CANYON COUNTY SOLID WASTE

Below are the responses to your comments received on January 10, 2025, on the Pickles Butte Sanitary Landfill Lateral Expansion Tentative Design Plan (Facility ID No. 027-00170). As documented in the responses, minor revisions were made to the expansion application. They are:

PICKLES BUTTE SANITARY LANDFILL

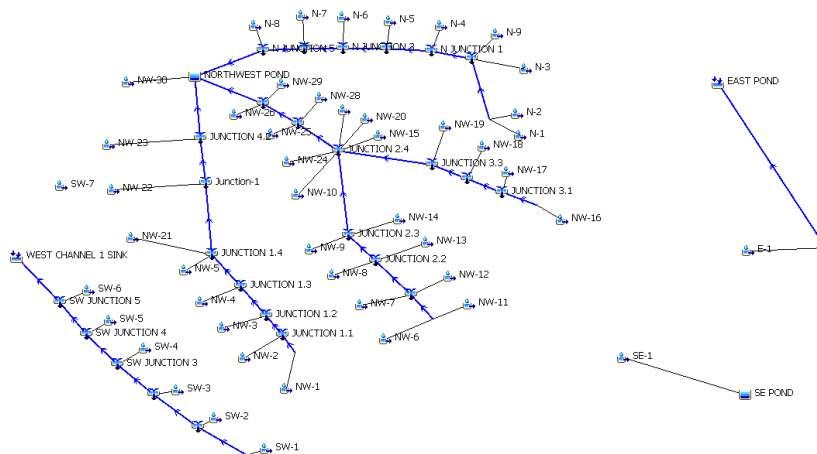
Appendix I - The HEC-HMS simulation run Global Results Summary table, on pdf page 24, identifies multiple different hydrologic elements. The design drawings provided in Appendix H do not provide the level of detail of the hydrologic elements used in HEC-HMS. It would be helpful to have a figure that identifies these hydrologic elements. Please provide a figure with the labeled drainage area IDs, reaches, down chutes, junctions, and channels.

The snippet below shows the layout of the hydrologic elements in HEC-HMS. A more detailed diagram has been included in the front of Appendix I.
